Inspection of Vocational Education Centers Built Under BEST II

SEPTEMBER 2000

INSPECTION OF VOCATIONAL EDUCATION CENTERS BUILT UNDER BEST II

PLAN OF DETAIL 1

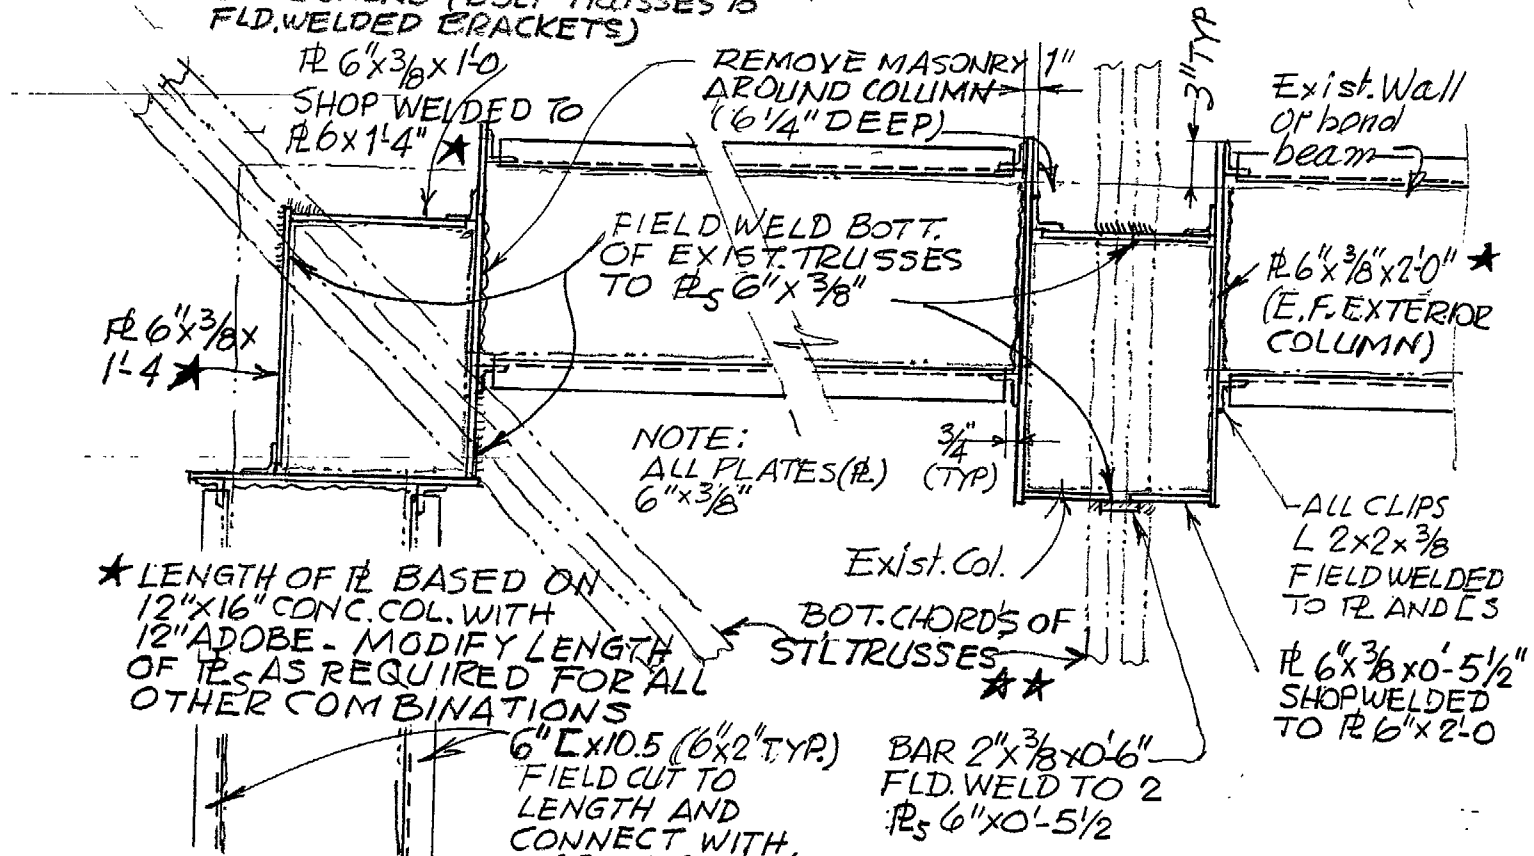
- A. Apply new continuous steel channel tie beam at bond beam level, both faces of wall similar to DETAIL 1.
- B. Repair cracks and under-filled bed or head joints in adobe walls. Do this by
- Removing paint on both sides of crack
 - Clean out debris, paint, and loose mortar from crack

- Attach galvanized wire mesh
 - at top, to new steel channel tie-beam as in DETAIL 2 and
 - at bottom, to new steel angle bolted to grade beam
 - Wrap corners 2 feet by overlapping the galvanized wire mesh

- Drill holes through wall, without use of impact tools
 - Thru-tie with nylon cable ties or 18 gauge galvanized wire the stucco mesh at 24 inches O.C throughout and in both directions, as in DETAIL 2

- Plaster both faces of all walls.
- D. Anchor roof trusses to tops of walls or columns by field welding bottom chords to newly placed steel bond beams or using steel brackets as appropriate for wood trusses (see DETAIL 1).

★★ FOR WOOD TRUSSES USE SIMILAR DETAILS EXCEPT FOR CONNECTIONS (BOLT TRUSSES TO FLD. WELDED BRACKETS)

★ LENGTH OF PLATE BASED ON 12"X16" CONC. COL. WITH 12" ADOBE - MODIFY LENGTH OF PLATE AS REQUIRED FOR ALL OTHER COMBINATIONS

NOTES: SET ALL PLATES AND CHANNELS FLUSH WITH BOTTOM OF STEEL TRUSSES & INJECT DRY PACK GROUT BETWEEN THEM AND MASONRY AFTER FIELD ASSEMBLY IS COMPLETED
